Subject: East Altamont Energy Center Application for Certification
Data Request Response Set #1 (01-AFC-04)

East Altamont Energy Center
Data Requests and Responses (01-AFC-4)
Set #1

EAST ALTAMONT ENERGY CENTER DATA REQUEST AND RESPONSE SET #1 (01-AFC-4)

Technical Area: Visual Resources

Figure 7.3d

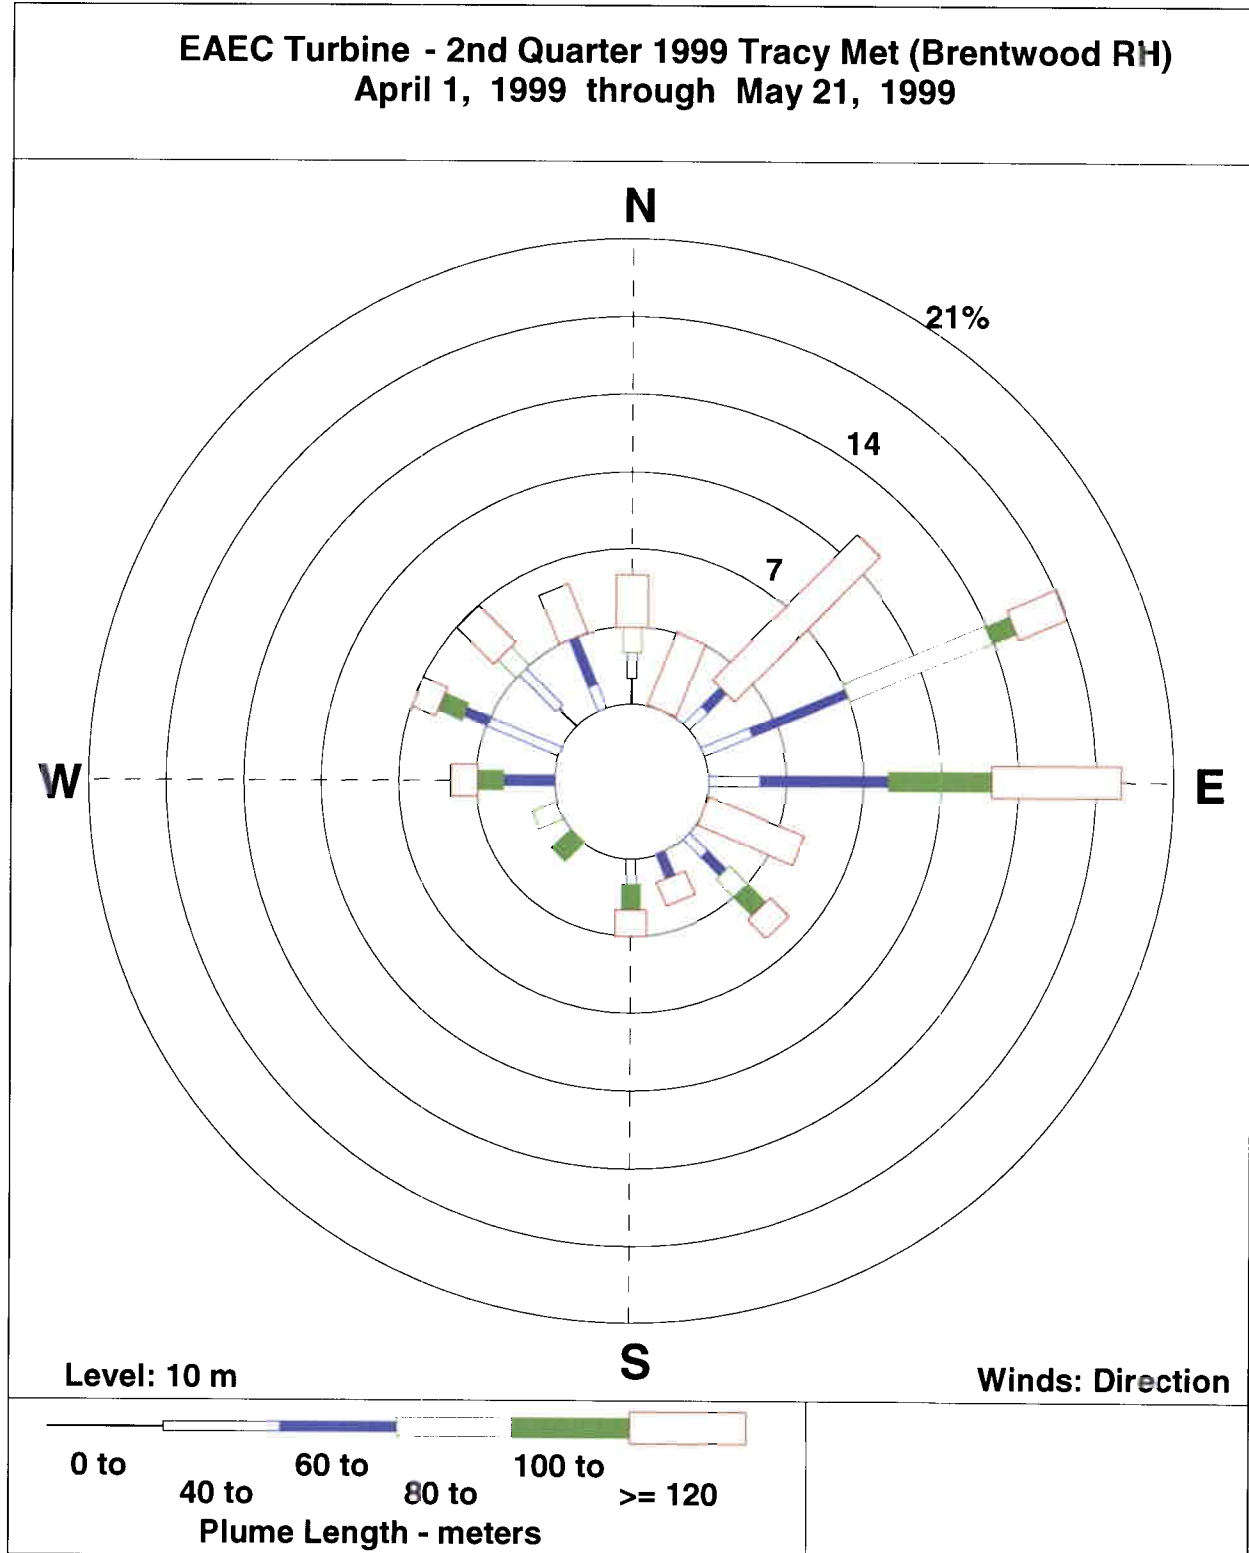
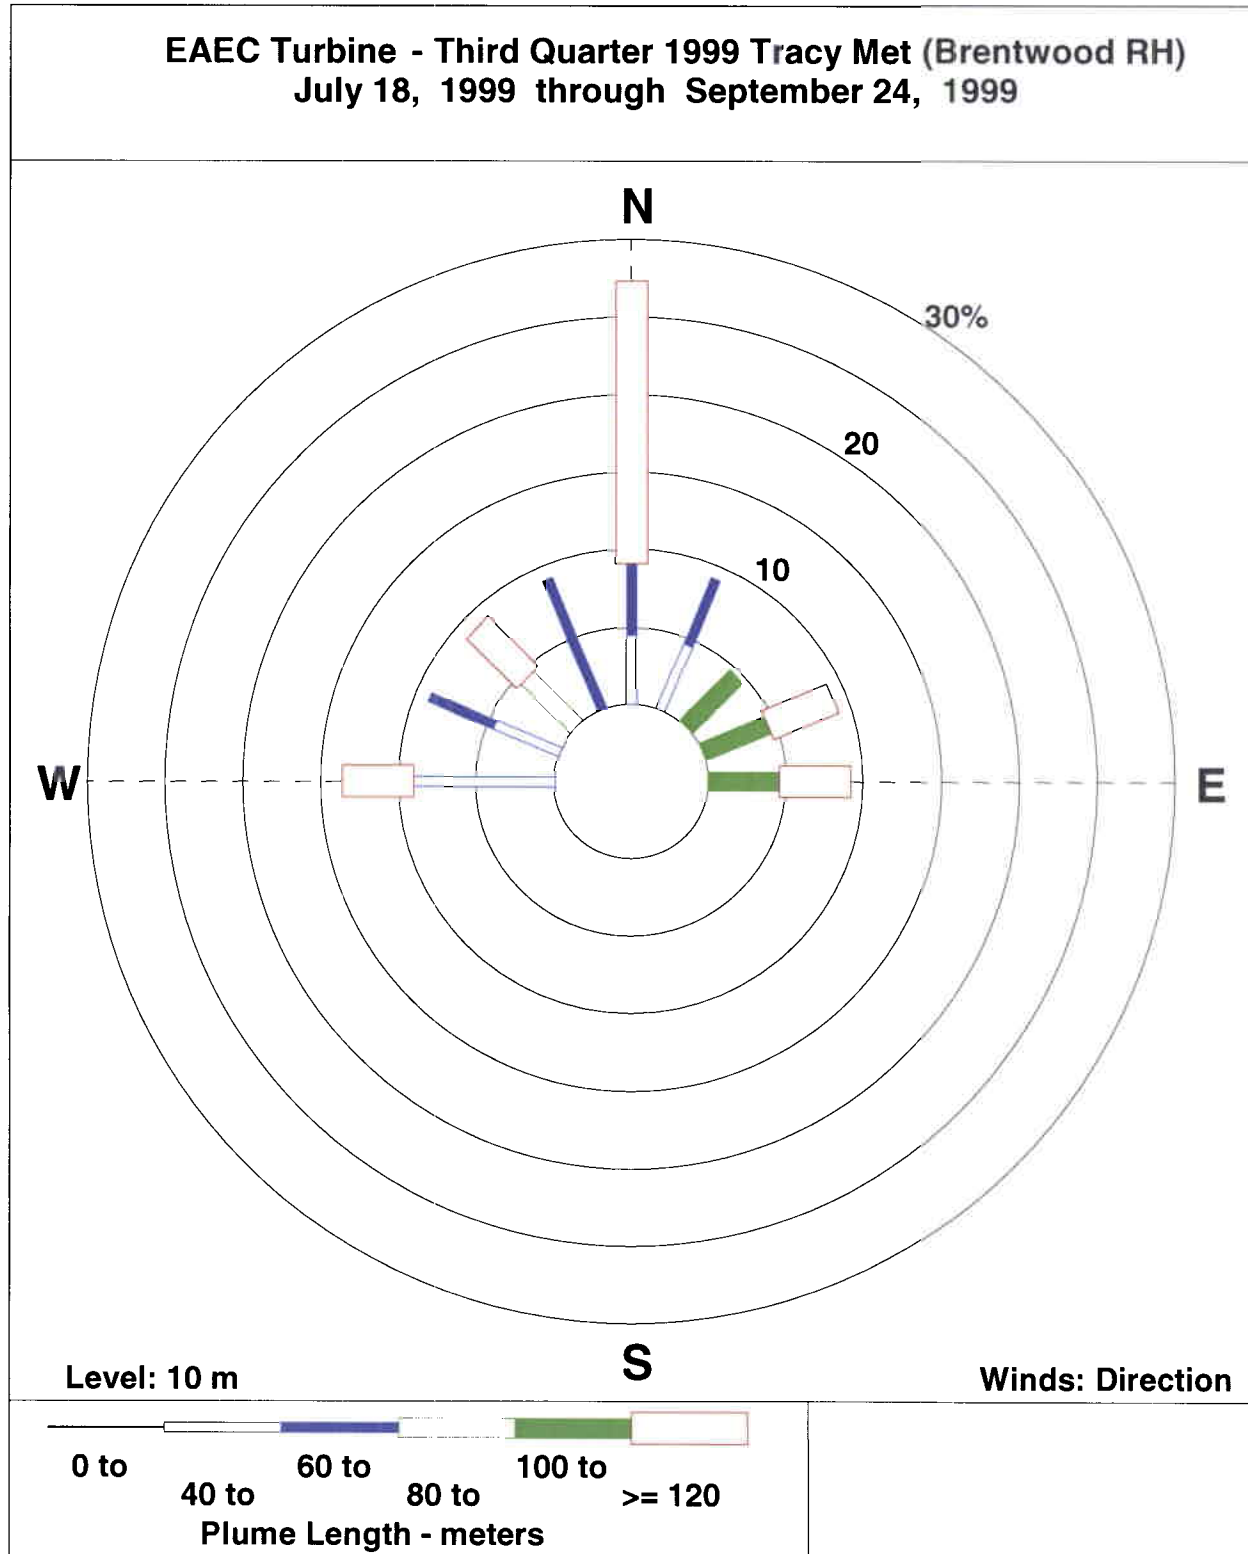
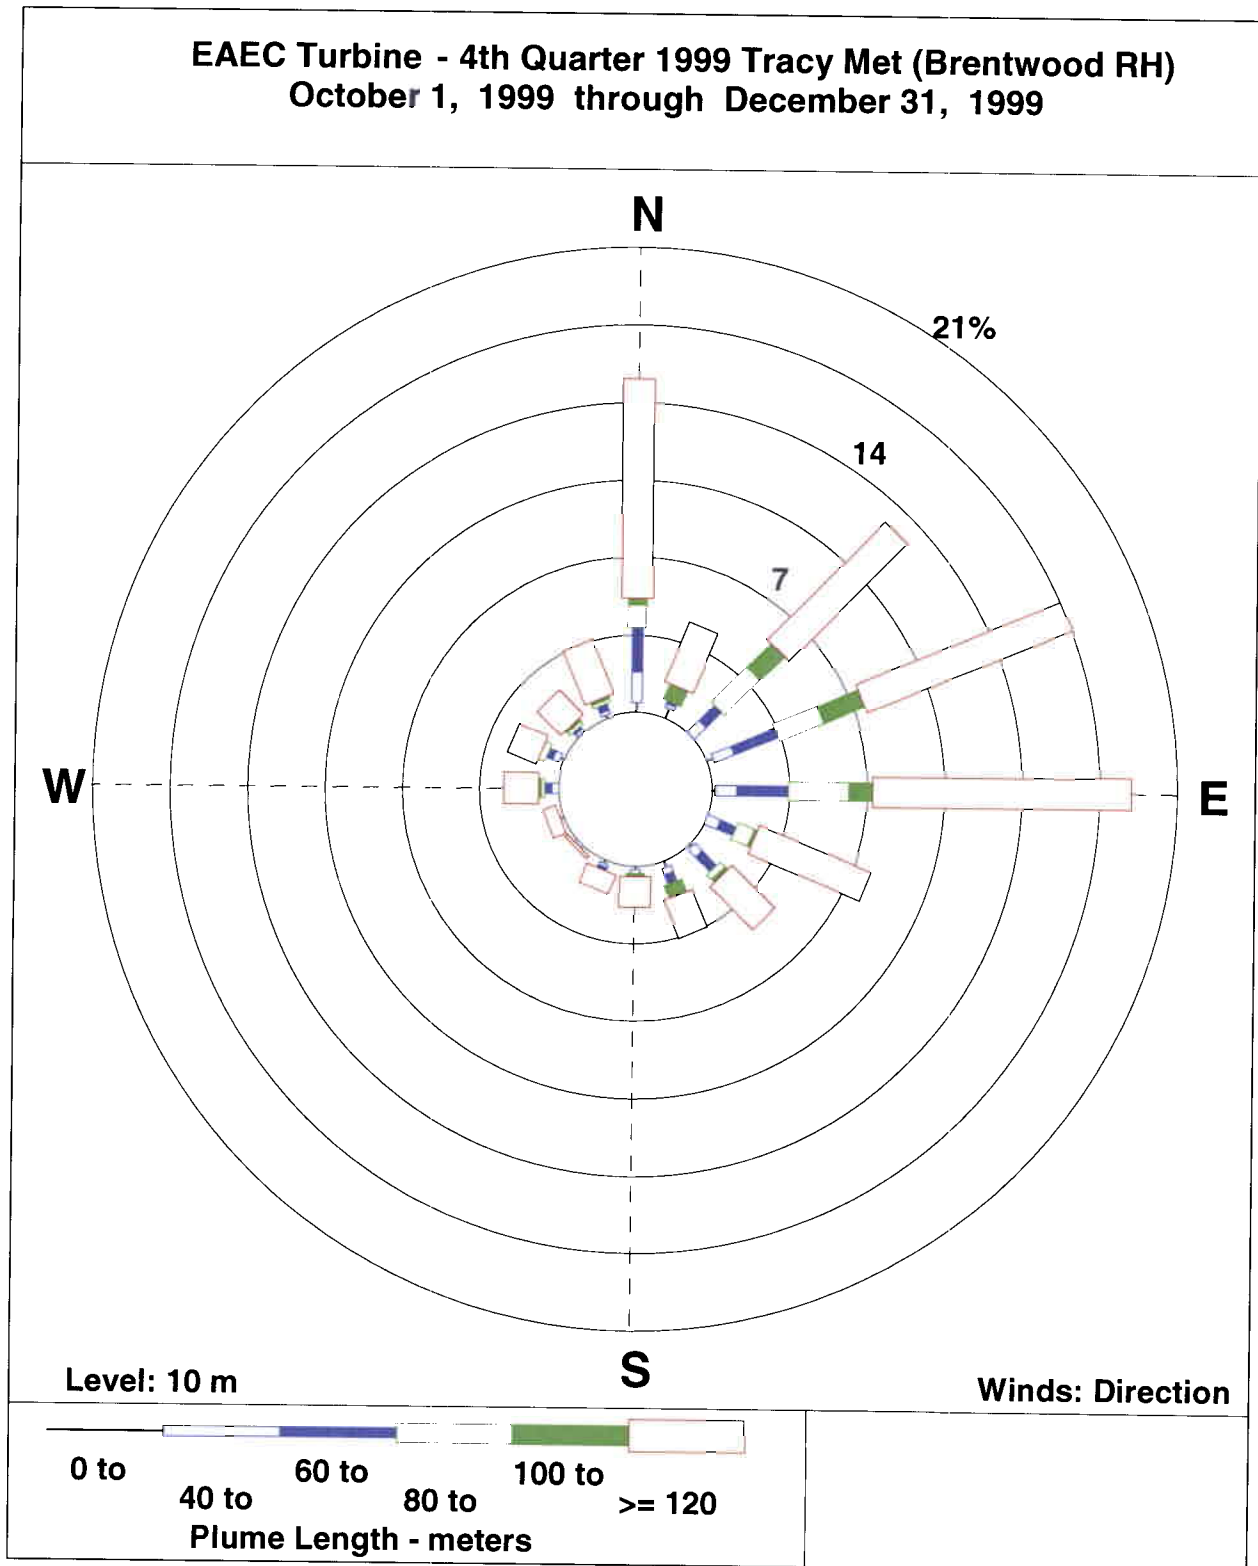
- a. The total number of daylight hours annually and seasonally;

Response: Table VIS-7.1 shows the number of hours per year that there is the potential for formation of a visible water vapor plume of various lengths from each HRSG stack. The analysis assumes that each HRSG is operated for 8,760 hours per year. During the hours between 6 a.m. and 8 p.m., the units are assumed to operate at full load with duct firing and power steam augmentation; during all other hours, the units are assumed to operate at full load, but without duct firing or power steam augmentation. The analysis was performed for each of the three years of meteorological data available.

A seasonal distribution of these hours is presented in the plume roses included as Figures VIS-7.1a through VIS-7.3e.

Figure LU-1

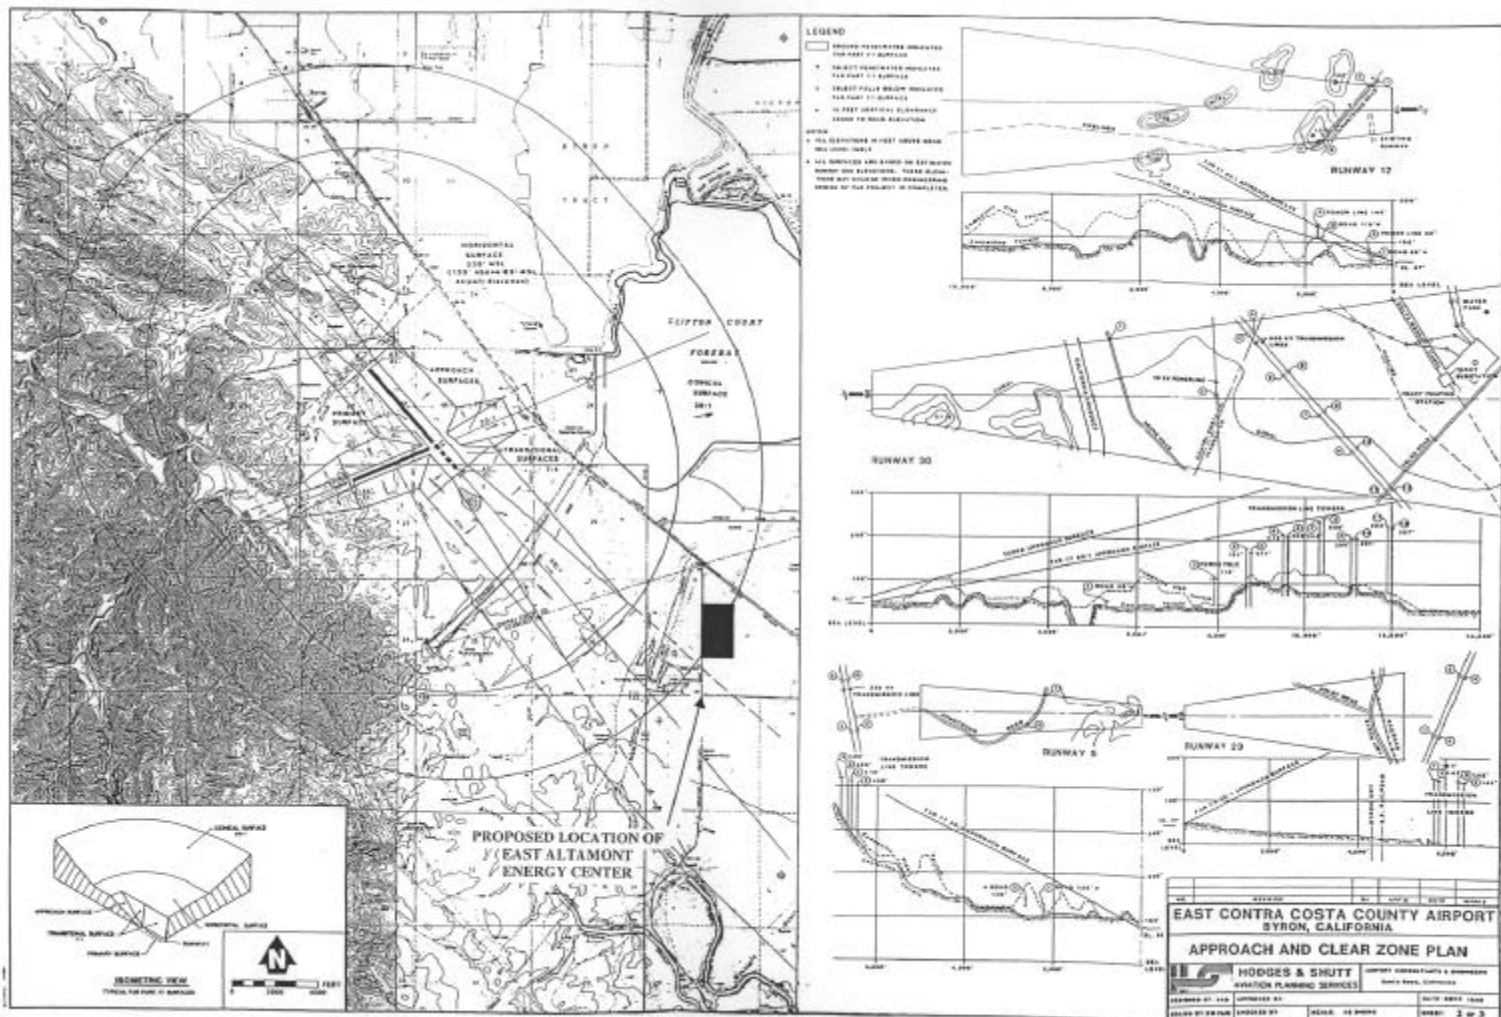
9. Staff requests that the applicant provide a copy of the current FAA approved "Approach and Clear Zone Plan" for the Byron Airport showing the exact location of the proposed power generation facility and transmission towers on it.

Response: Based on discussions with the Byron Airport staff (K.C. Coyle 925-646-5722), the Approach and Clear Zone Plan does not undergo review and approval by the FAA, but that the Airport Layout Plan does undergo FAA review and approval. According to the Approach and Clear Zone Plan contained in the *East Contra Costa County Airport Master Plan Report, Byron, California*, dated May 1986 (Master Plan), a portion of the EAEC lies within the 20:1 conical surface on the southeast side of Byron Airport. The proposed site is located approximately 2.8 miles from the nearest point of the nearest runway, Runway 12-30. This runway is currently 4,350 feet in length, with a possible expansion to 6,000 feet under consideration by the County (Master Plan, 1986). A copy of the Approach and Clear Zone Plan, marked with the proposed location of the EAEC, is attached as Figure LU-1.
